## Process Sheet

| Customer              | : CU-DAR001 Dart Helicopters Services   | Drawing Name     | : AFT TUBE ASSEMBLY |
| This Issue            | : 2/8/2007  | Drawing Number   | : D3391 REV E       |

**From:** Peter Hum [phum@dartaero.com]  
**Sent:** February 23, 2007 1:51 PM  
**To:** 'Bill Beckett'; 'S Shahbazian'; 'David Shepherd'  
**Subject:** RE: Dart 412 skidtube with Apical Floats

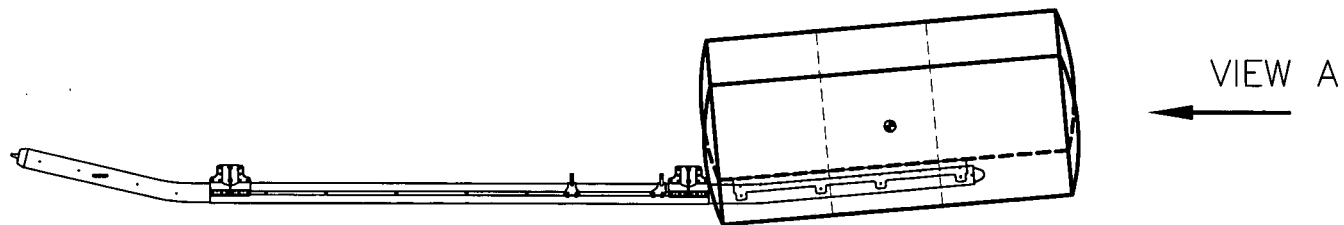
I do not see an issue from a functional standpoint but, I am concerned that customers would object to their packed aft floats not being in alignment with the fwd and mid floats, especially since the aft floats will both lean to one side.

The aft float bag hole provisions are designed in order to have the aft float bag be vertical (i.e. the girt is 90 degrees to the horizontal)

In the manufacturing of the aft portion of the skidtube. The holes for the girt we have made are rotated 6.5 degrees with respect to the vertical, this was a manufacturing error. Therefore, when the bag is installed/or deployed it will be rotated 6.5 degrees (inboard or outboard). It will be inboard or outboard depending on which side of the aircraft the skidtube is installed, because the Dart 412 float skids aren't handed.

Is having the aft float bag rotated by 6.5 degrees inboard or outboard still acceptable for installation on aircraft?

As discussed with Bill, we have decided to allow the release of these skidtubes with the deviation noted below
